Change Number C-93-1	Federal Facility Agreement and Consent Order Change Control Form Do not use blue ink. Type or print using black ink.	Date 02/03/94
-------------------------	--	------------------

Change Title
 CONSOLIDATE OPERABLE UNITS 100-DR-2 AND 100-DR-3

Description/Justification of Change

100-D/DR AREA

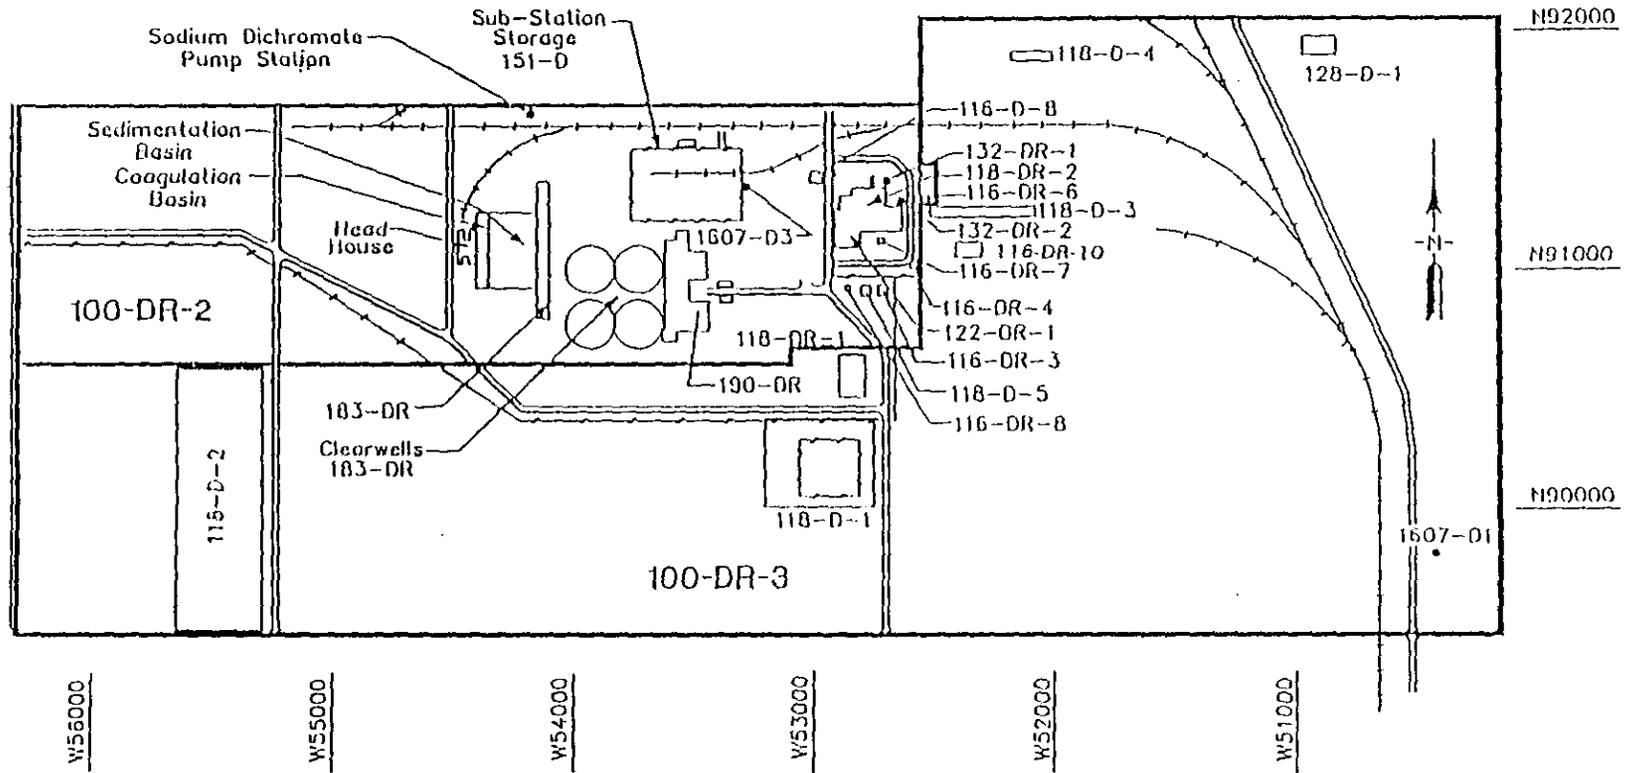
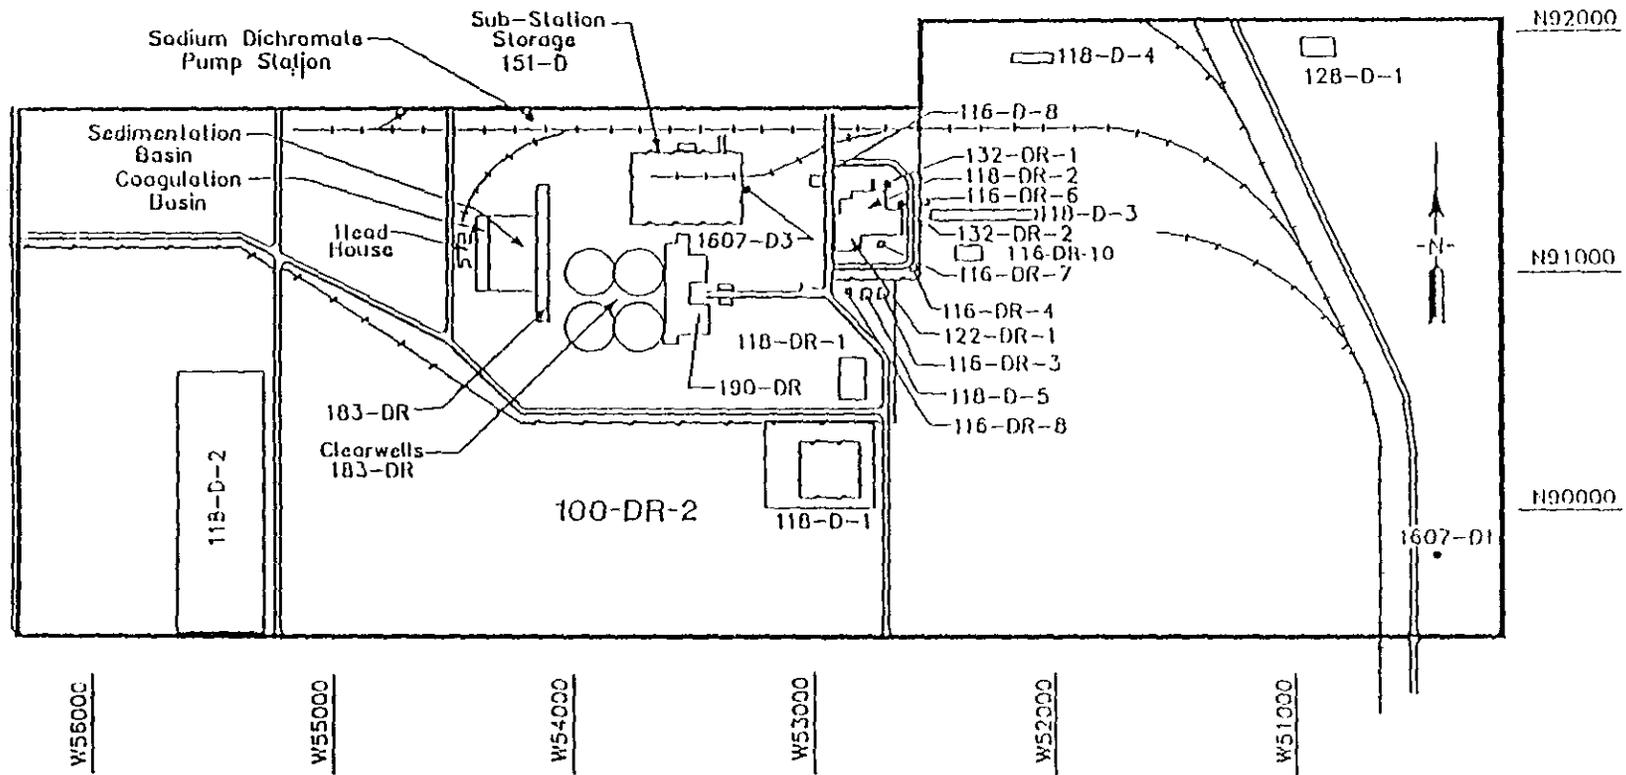
1. Change the 100-DR-2 Operable Unit (OU) boundary to include the 100-DR-3 OU waste sites. The U.S. Department of Energy, Richland Operations Office, U.S. Environmental Protection Agency, and the State of Washington Department of Ecology, agree that consolidating the 100-DR-3 OU into the 100-DR-2 OU will allow for a more efficient and effective limited field investigation (LFI) of the remaining 100-DR reactor area waste sites.

SITES ASSOCIATED WITH THE NEW 100-DR-2 OPERABLE UNIT

ORIGINAL 100-DR-2 SITES	ADDITIONAL 100-DR-2 SITES (PREVIOUSLY 100-DR-3)
116-D-8 (100-D Cask Storage Pad)	118-D-1 (100-D Burial Ground No. 1)
116-DR-3 (105-DR Storage Basin Trench)	118-D-2 (100-D Burial Ground No. 2)
116-DR-4 (105-DR Pluto Crib)	118-D-3 (100-D Burial Ground No. 3)
116-DR-6 (1608-DR Liquid Disposal Trench)	118-D-4 (Construction Burial Ground)
116-DR-7 (105-DR Inkwell Crib)	118-DR-1 (105-DR Gas Loop Burial Ground)
116-DR-8 (117-DR Crib)	128-D-1 (100 D/DR Burning Pit)
132-DR-1 (1608-DR Waste Water Pumping Station)	116-DR-10 (Pit)
Sodium Dichromate Tanker Car Off-Loading Facility	1607-D1:
118-D-5 (Ball 3X Burial Ground)	(1607-D1 Septic Tank Associated Drain Field)
126-DR-1 (190-DR Clearwell Tank Pit)	(1607-D1 Sanitary Sewer System, 1607-D1 Septic Tank)
1607-D-3 (Septic Tank and Associated Drain Field)	
118-DR-2 (105-DR Reactor Building)	
122-DR-1 (105-DR Sodium Fire Facility)	
132-DR-2 (116-DR Reactor Exhaust Stack)
